Title:	RN IPC H5 Cameras FW v5.5.70	Version:	V5.5.70	Date:	060920
Product:	DS-2CD6984G0-IHS PanoVu Cameras	Build:	200514	Page:	1 of 6
Action Required:	None, Information Only

Firmware has been upgraded to add new features, fix bugs, enhance product quality, and meet customers' requirements.

Device Models: DS-2CD6984G0-IHS	Firmware Version	5.5.70 build 200514
	I-Series NVR Firmware Version	4.40.010 build 200430

Figure 1, Panorama Mode Added

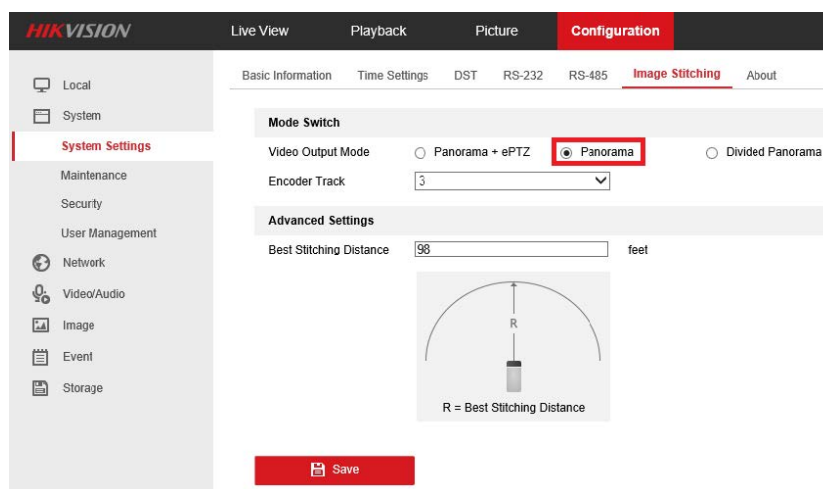
- 32 MP Panorama Mode has been added. It can be accessed by proceeding as follows: **System → System Settings → Image Stitching → Mode Switch → Panorama**

Figure 2, Motion Detection Menu in Panorama Mode

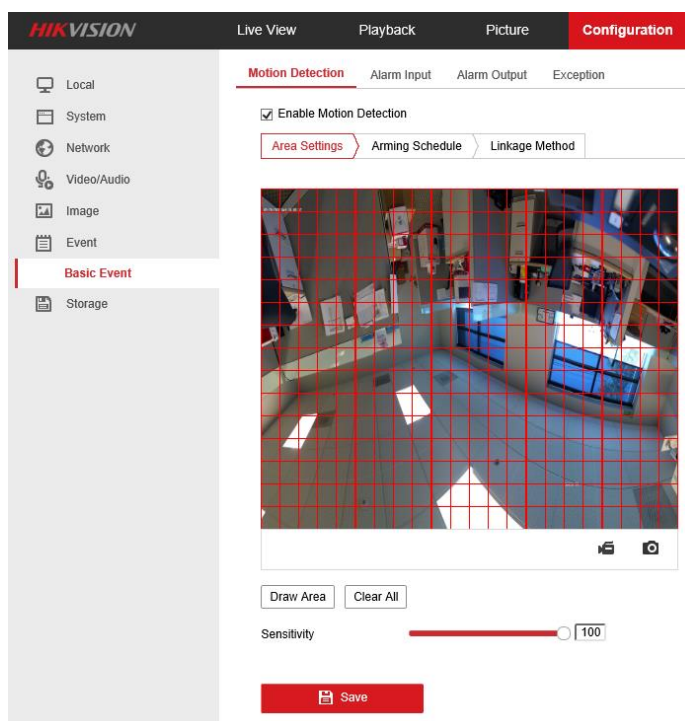
- Motion Detection has been added in the panoramic channel of *Panorama Mode* and *Panorama + ePTZ Mode*. It can be accessed by proceeding as follows: **Configuration → Event → Basic Event → Motion Detection → Enable Motion Detection**

Figure 4, Available Frame Rate Options in Panorama Mode

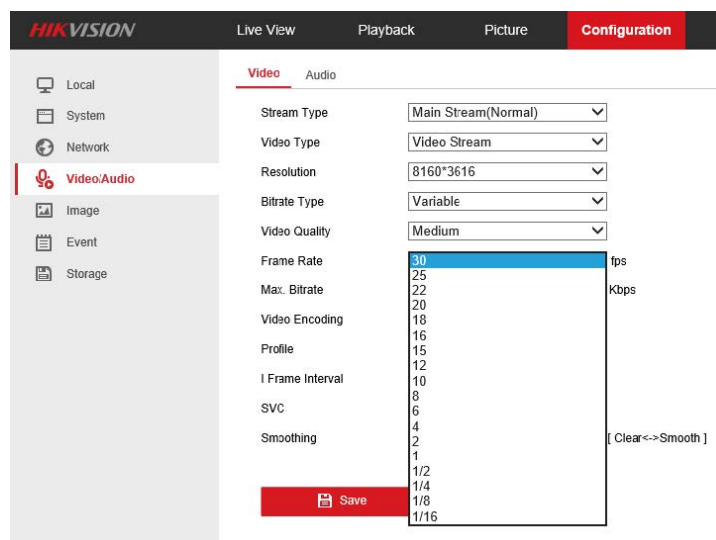
- In *Panorama Mode*, the default frame rate is 25/30 fps. It can be accessed by proceeding as follows: **Configuration → Video/Audio → Frame Rate**

Figure 5, Error Message when Channel D1 Not Selected

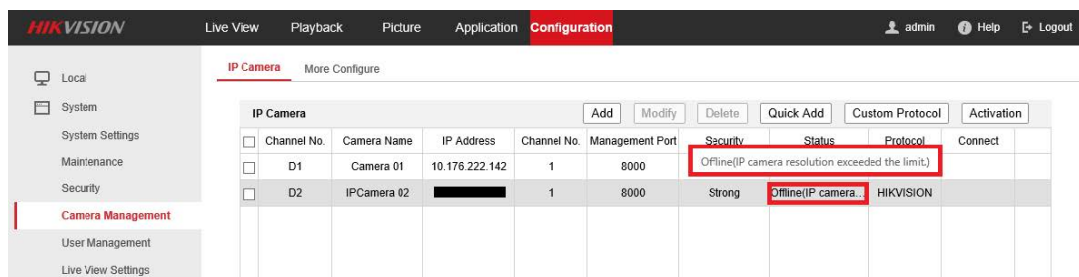
- Compatibility with DS-96xxNI-I8 NVRs only. Other NVRs do not support this feature.
- DS-2CD6984G0-IHS *Panorama Mode* can only be added to the first channel (D1) of the NVR. Adding the mode to any other channel will result in a resolution or bitrate error, or will cause the camera to appear offline.

Figure 6, Error Message when Ultra HD Not Enabled

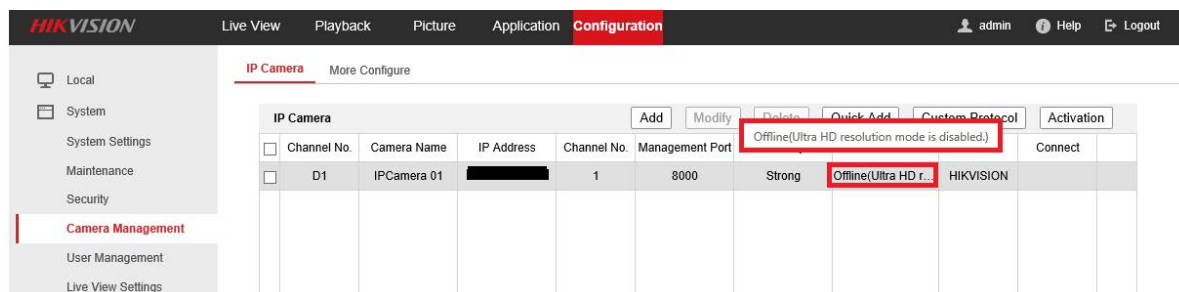
- **Ultra HD Resolution** must be enabled from the NVR's camera management menu. Otherwise, the DS-2CD6984G0-IHS camera will appear offline on the camera list and return an error.
